Fresno - Bakersfield (2014 June+) - RECORD #398 DETAIL

## Response to Submission I001 (Donna Nelson, January 16, 2018)

**Figure 4 Project Phase I**

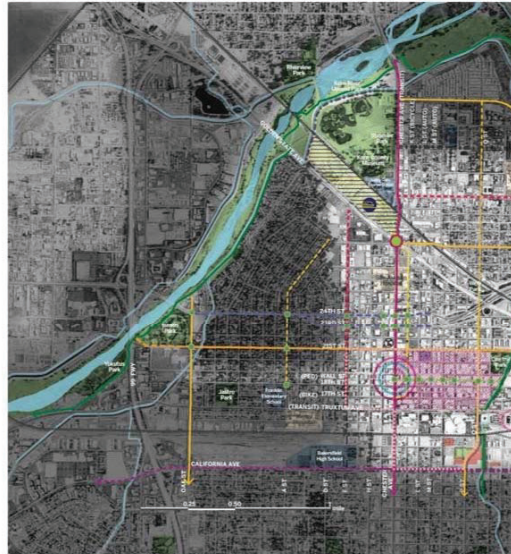
**Subject:** FW: F St Station  
**Attachments:** Figure 4.jpeg

Refer to Standard Response FB-LGA-Response-GENERAL-02: Public Outreach, FB-LGA-Response-GENERAL-10: Comments with Opinion Only.
